CITY DEVELOPMENT REVIEW BOARD STAFF REPORT

PROJECT NAME AND NUMBER: Tower Road Investment Group, LLP, Markets West Petition DB-19-26

APPLICATION TYPE: Master Plan review for a commercial and office park on 8.36 acres with preliminary development plan approval of Phase I,

| SHEET NO. | C000 |

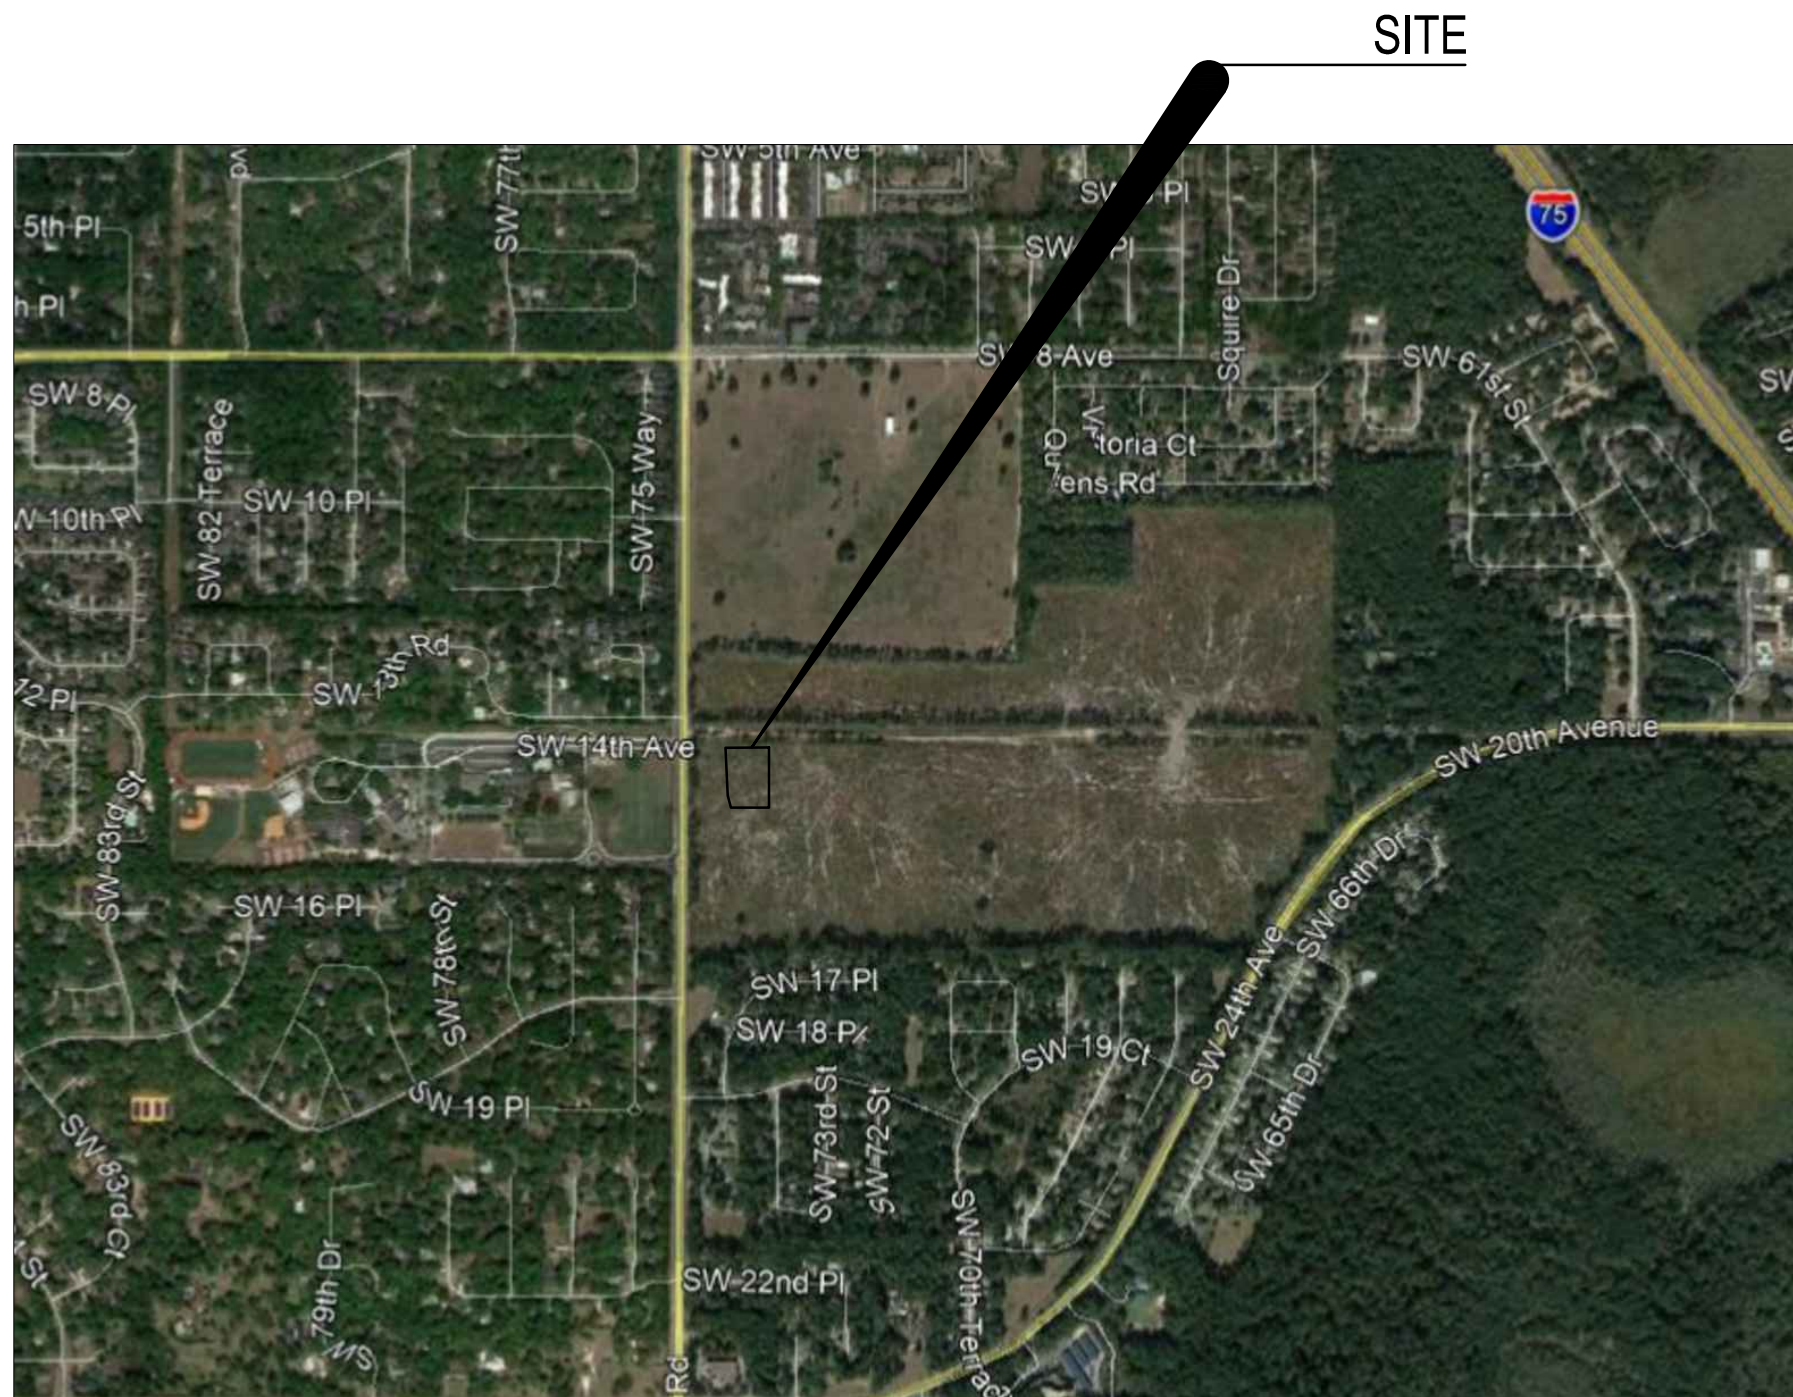
| Resolved | Transportation Mobility | C000 COVER SHEET.pdf | <p>1. Please provide the estimated average daily trip generation for this proposed use in the traffic information table on sheet C000. It is unclear where this health/fitness club use is accounted for in the traffic study for the Tower Road Mixed Use.</p> <p>2. Indicate the ITE number for the proposed health/fitness club use.</p> | 03/19/2019 5:05 PM | Corrected. |

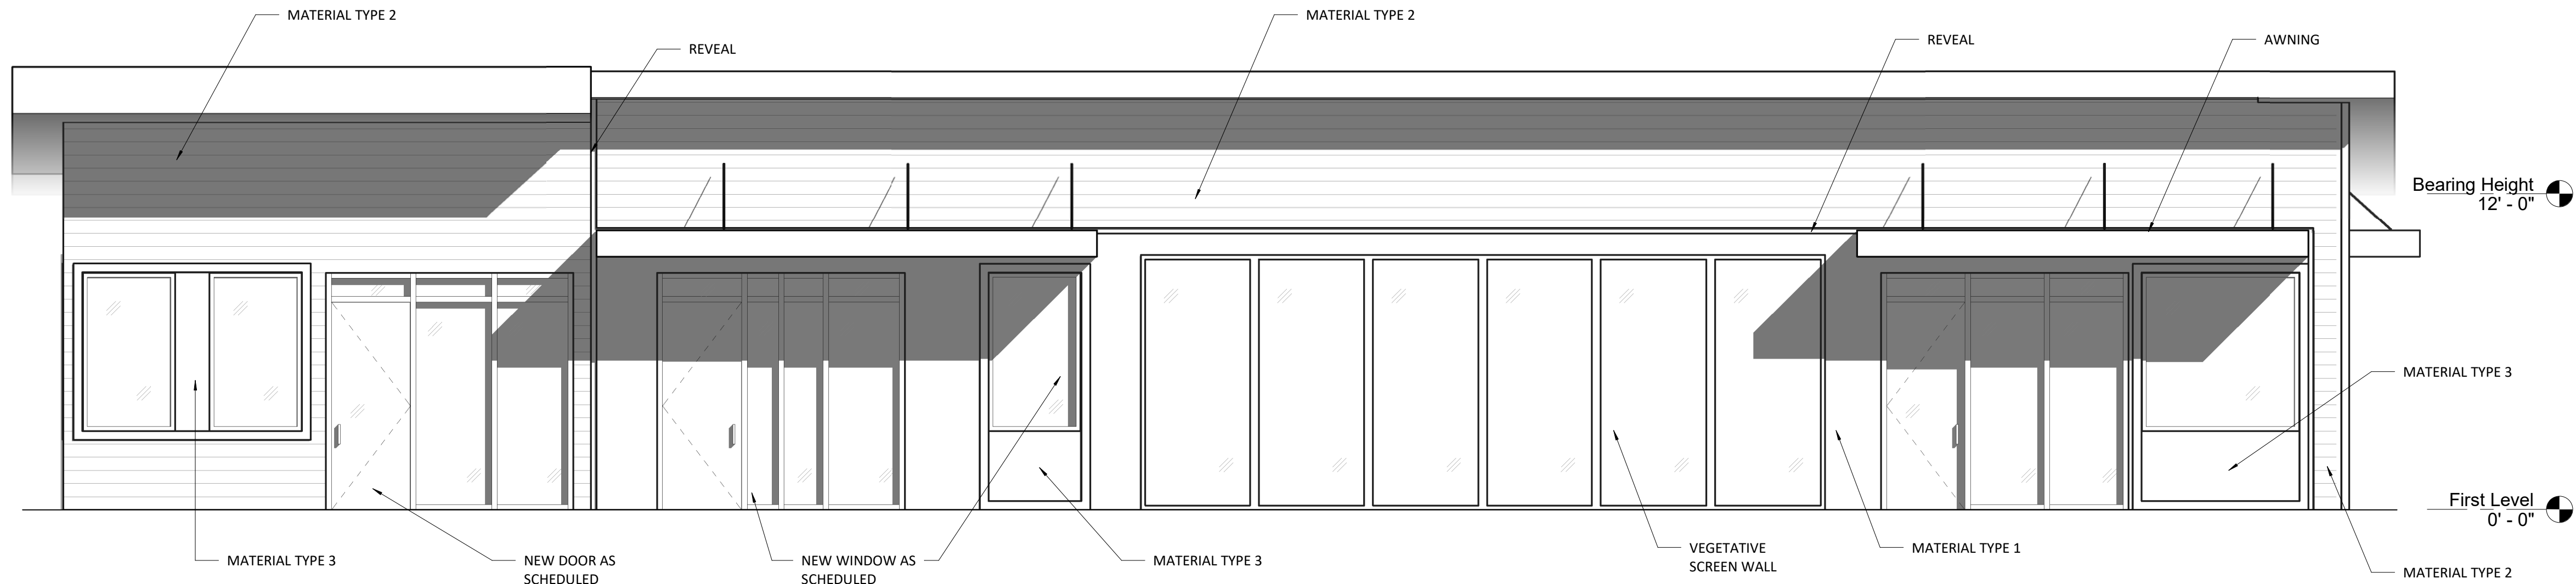
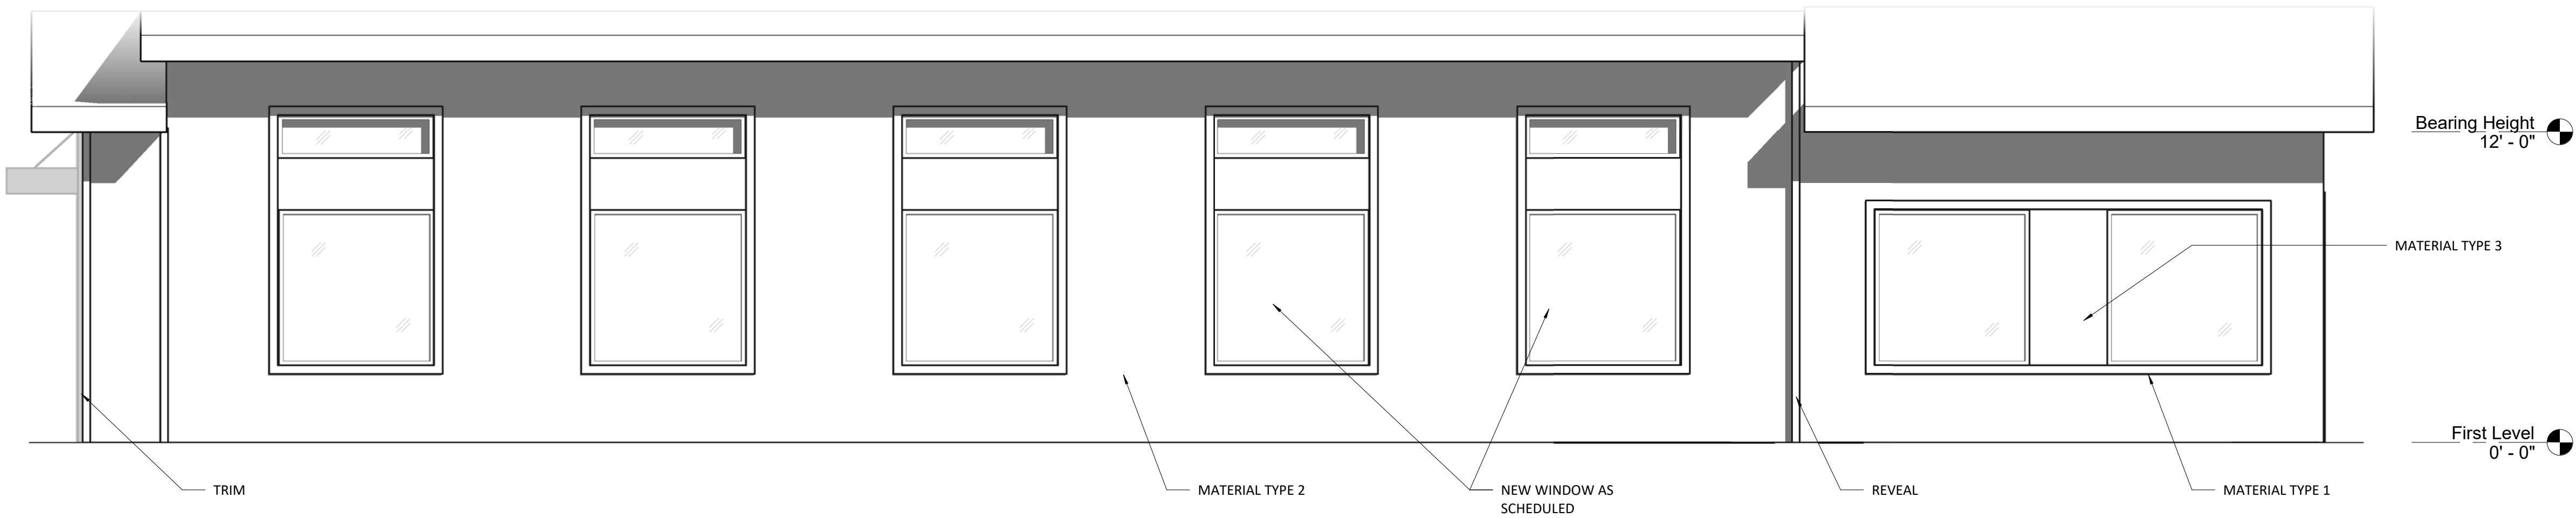
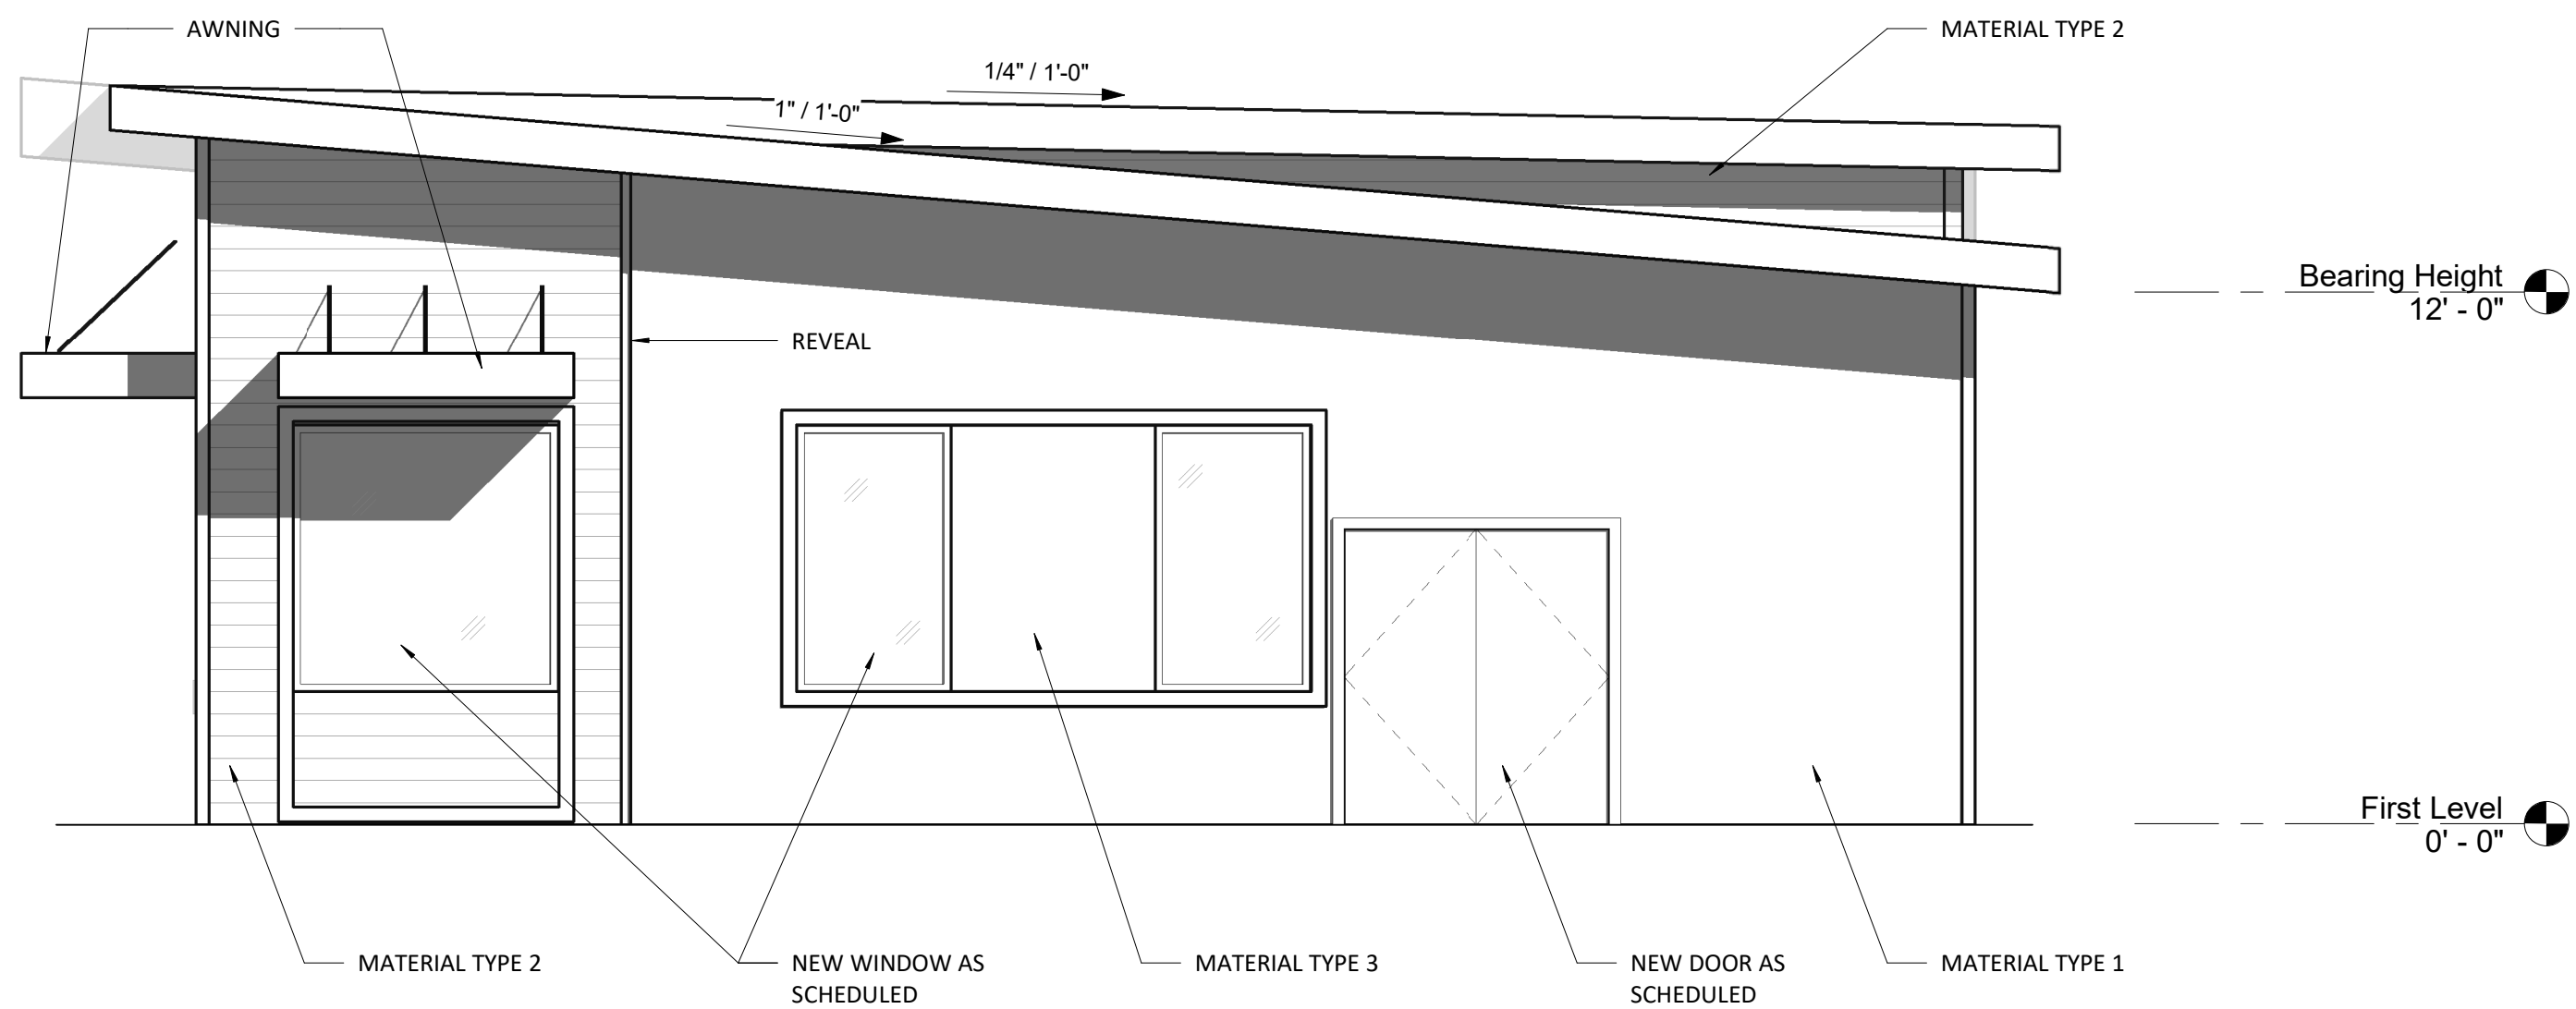
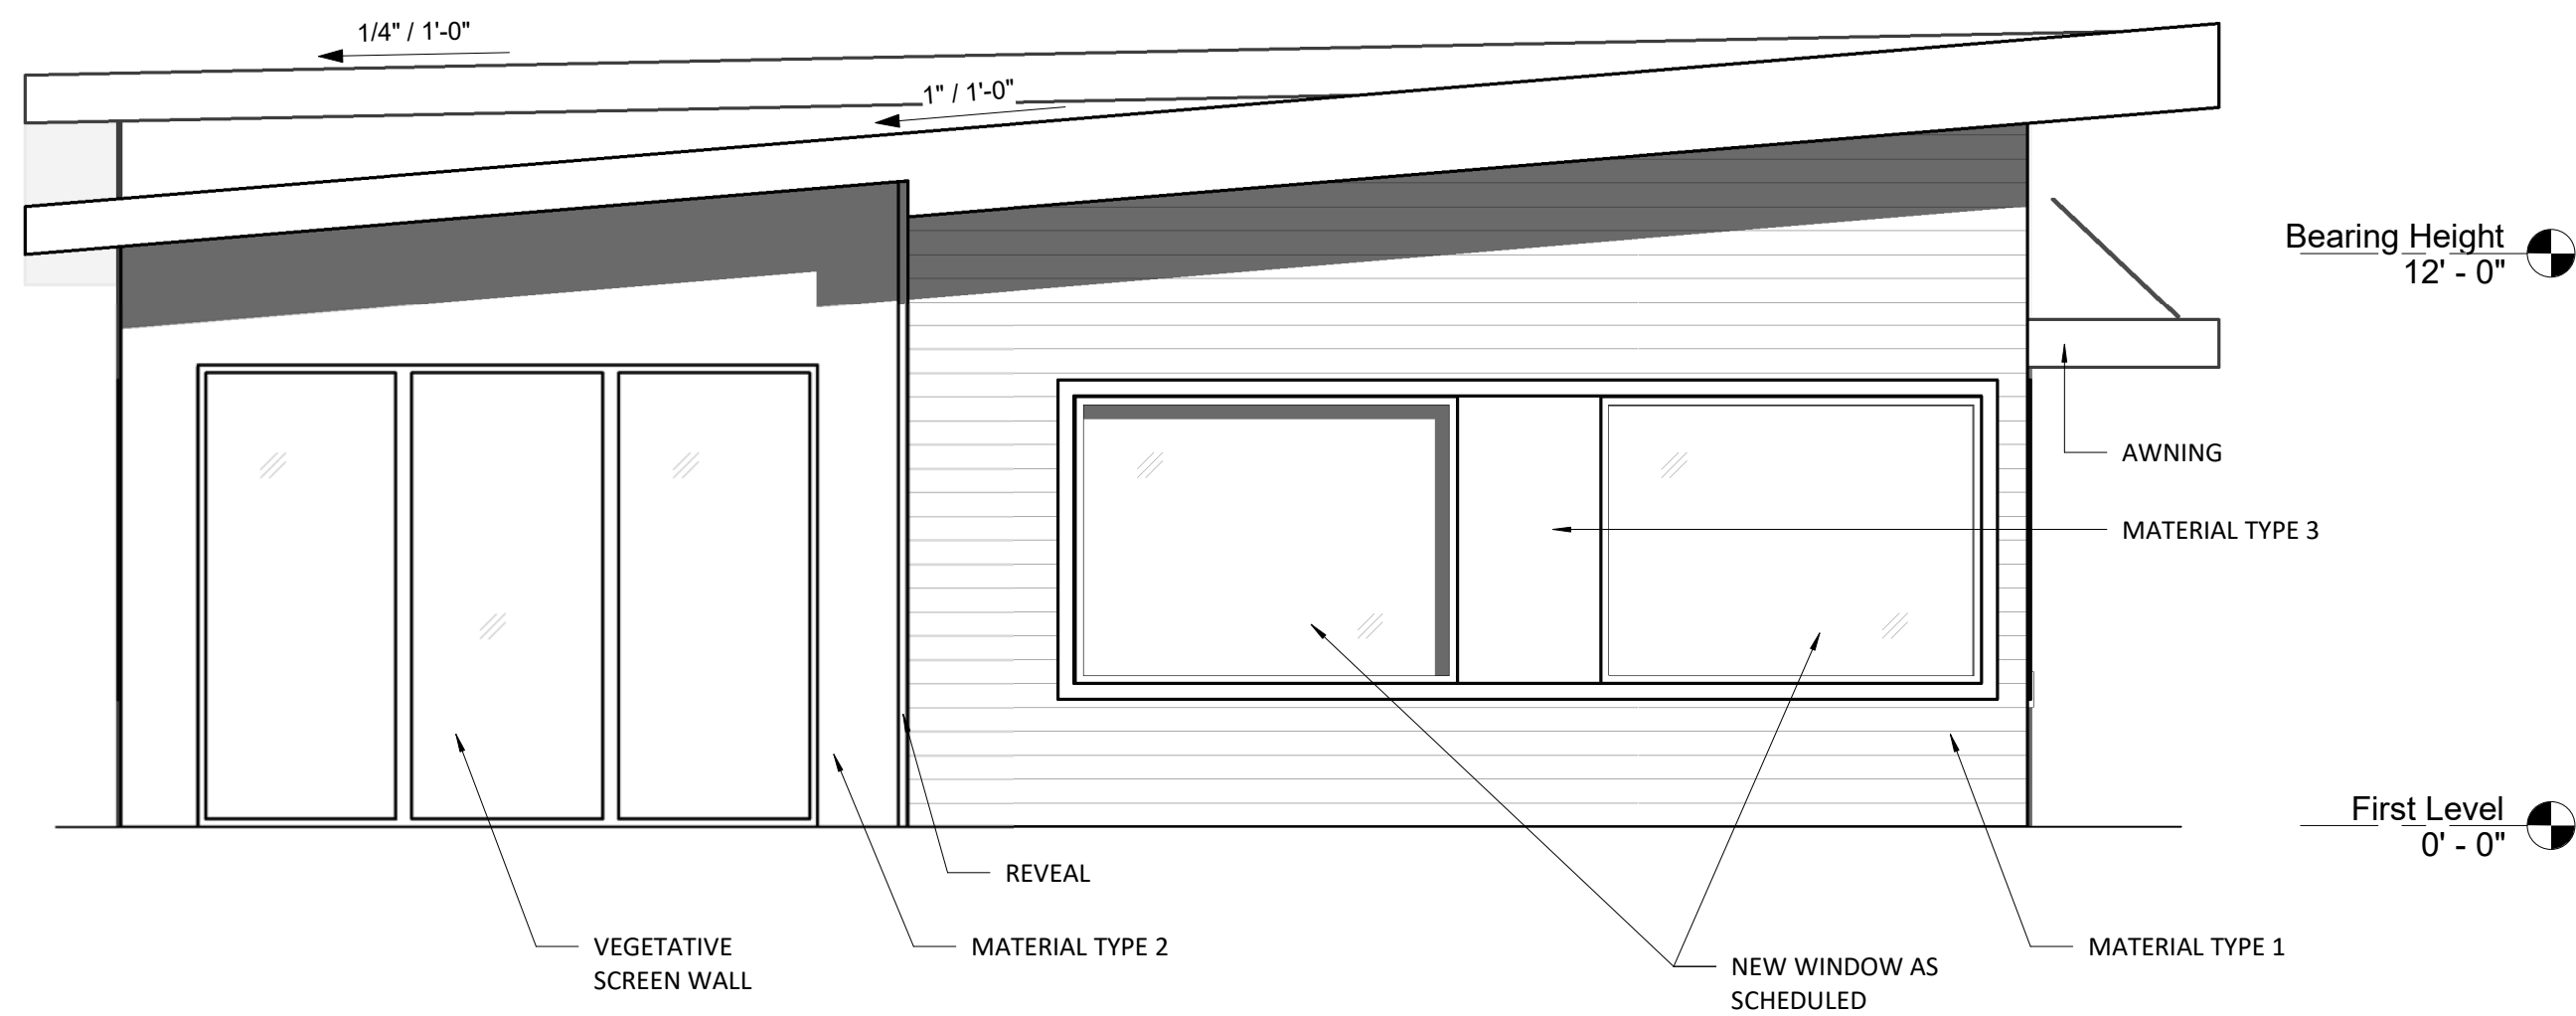
| Resolved | Planners | A2.0 Elevations.pdf | 1. Which is the front and the primary entrance. Please show Glazing. | 03/25/2019 12:33 PM | Elevations have been revised. |
